MIL-M-28787/241
AMENDMENT 1
16 December 1992

MILITARY SPECIFICATION

MODULES, STANDARD ELECTRONIC

DRIVER, INTERFACE, NTDS (ANEW), KEY CODE QDR

FIGURE 17. Power supply current (low-level and high-level outputs) test circuit for table XV.

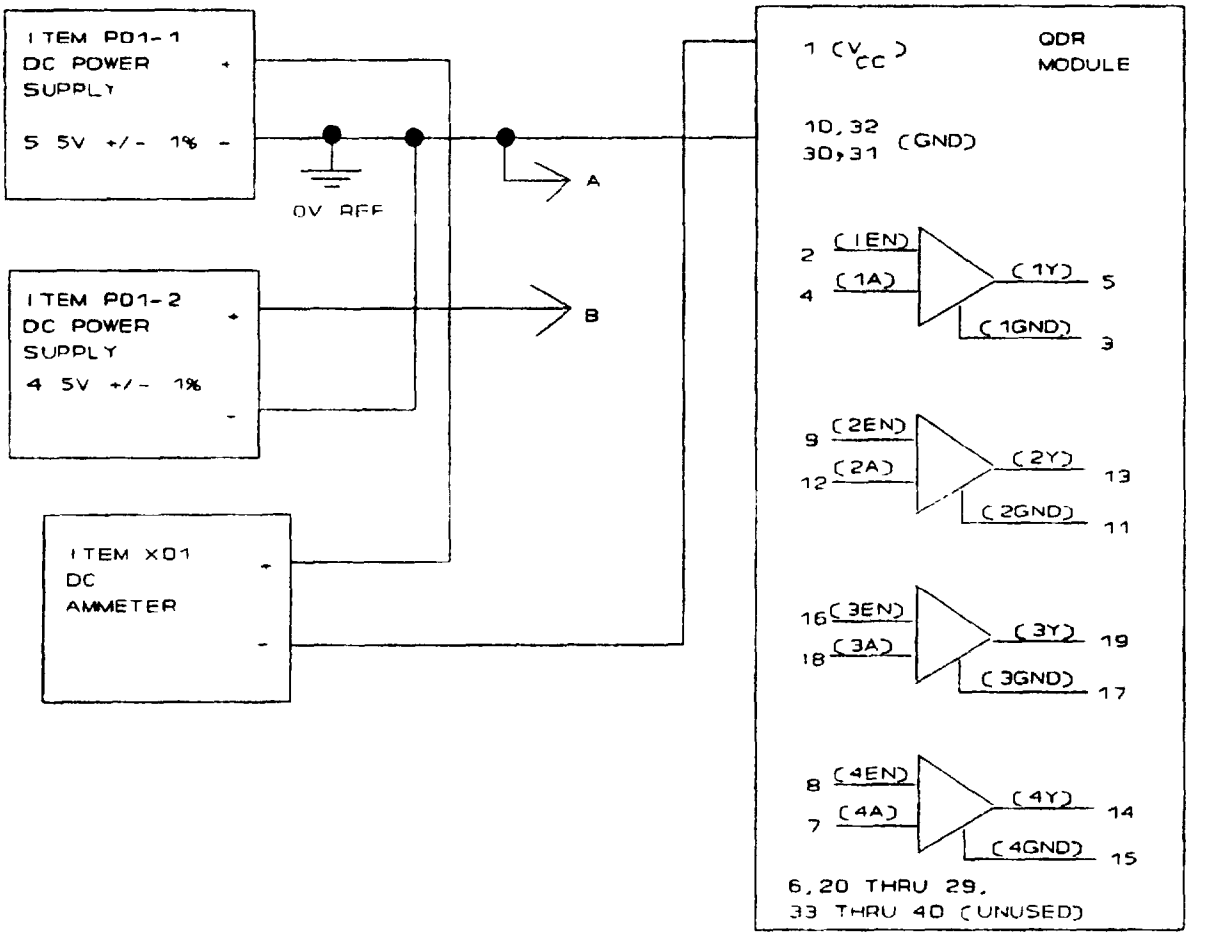
FIGURE 17: Delete and substitute new figure 17 as printed on page 4 of this amendment.

CAUTION: Do not isolate the chassis of ammeter X01 from earth ground.

FIGURE 26. Power supply filter capacitance test circuit for table XXI.

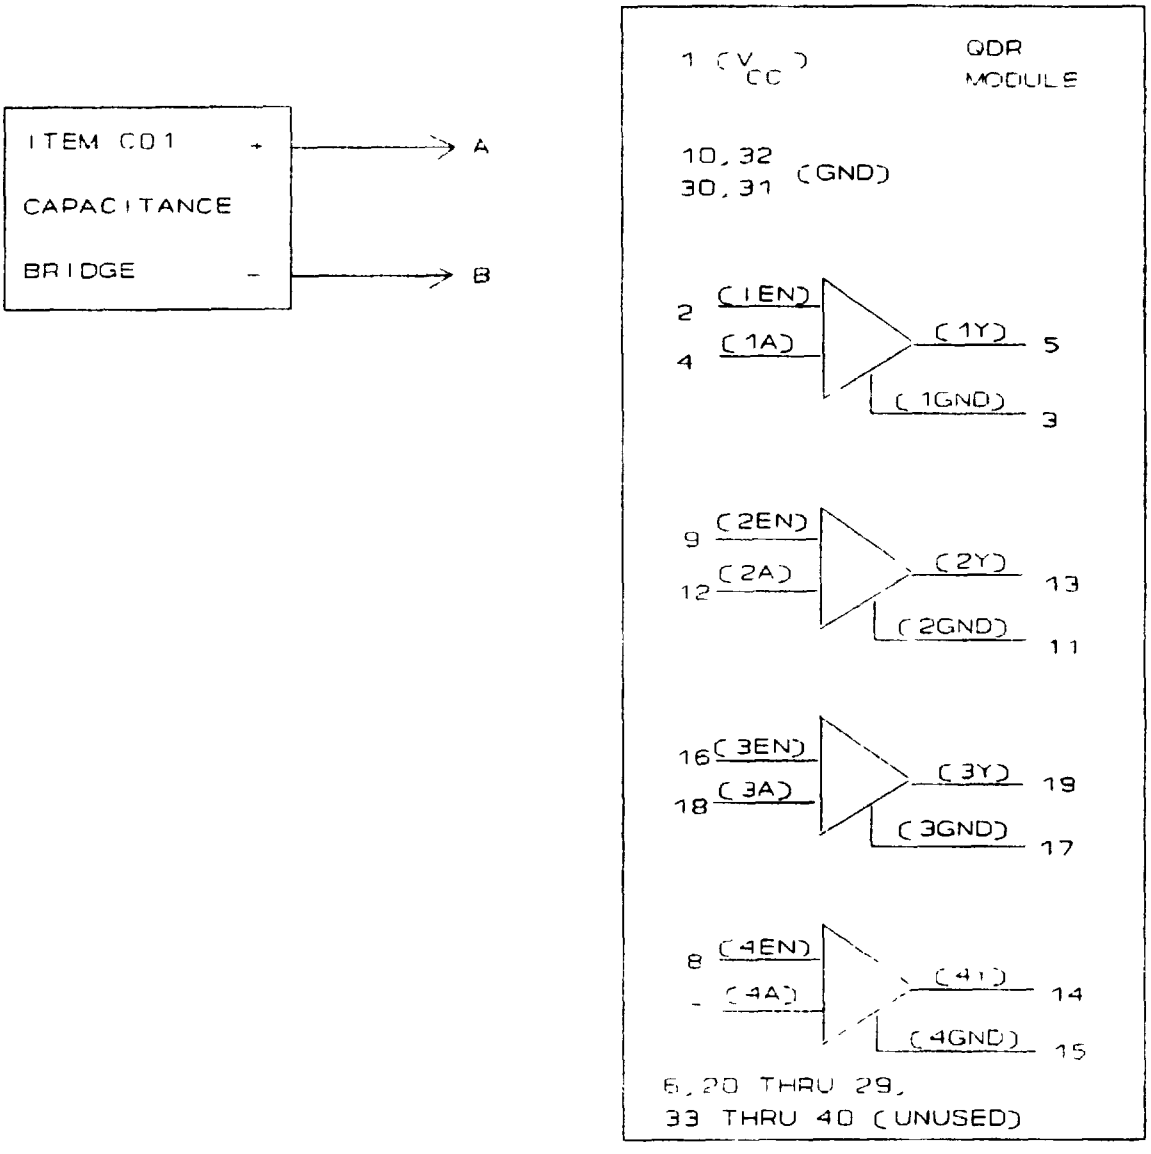
FIGURE 26: Delete and substitute new figure 26 as printed on page 6 of this amendment.

NOTE: **Item C01 setup:**
V_{pk} = 0.3 V maximum.
Frequency = 1 kHz ± 10 percent.
